Lynn Valley Road Underpass Project - Follow Up

We have taken another look at any final modifications to the design that could be accommodated here, and I can provide you with the following update in relation to the 2 highlighted points in your letter:

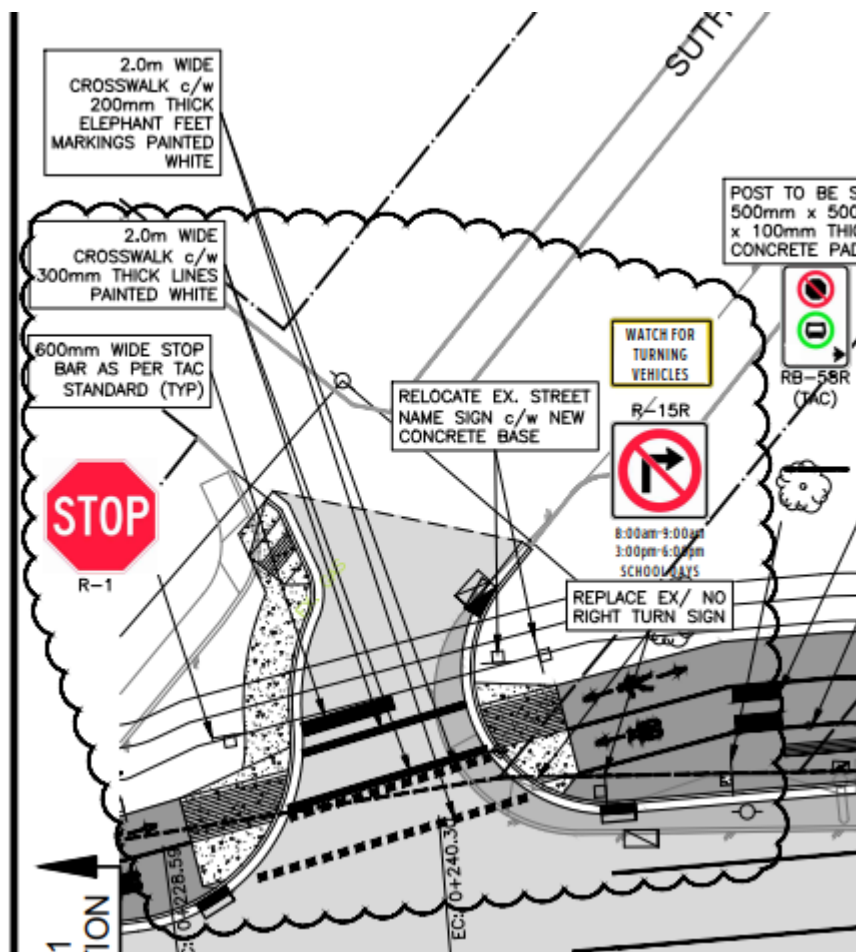
2. Sutherland crossing – We have now separated the cyclists and pedestrians for the crossing at Sutherland, with elephant feet highlighting the cyclist portion of the crossing. The response regarding the green paint is unchanged. The revised configuration will look like the screenshot below.
